Have You Modified Your M249s?

All M249 machine guns should have been modified by now with MWOs 9-1005-201-50-1 and 9-1005-201-30-6.

Feed tray assembly MWO 9-1005-201-50-1

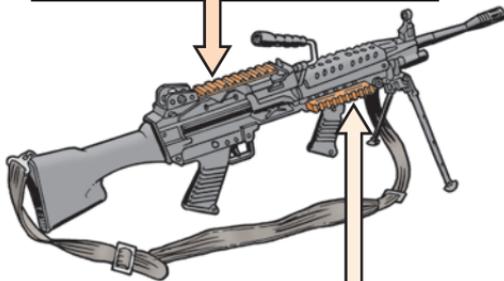
MWO 9-1005-201-50-1 added an accessory mounting rail to the feed tray cover. That enabled Soldiers to mount the AN/PEQ-2A and AN/PAQ-4B/C laser pointer/illuminators, AN/PAS-13 thermal weapon sight, AN/PVS-4 night vision sight, M145 machine gun optic, and combat identification system for dismounted Soldiers (CISDS).
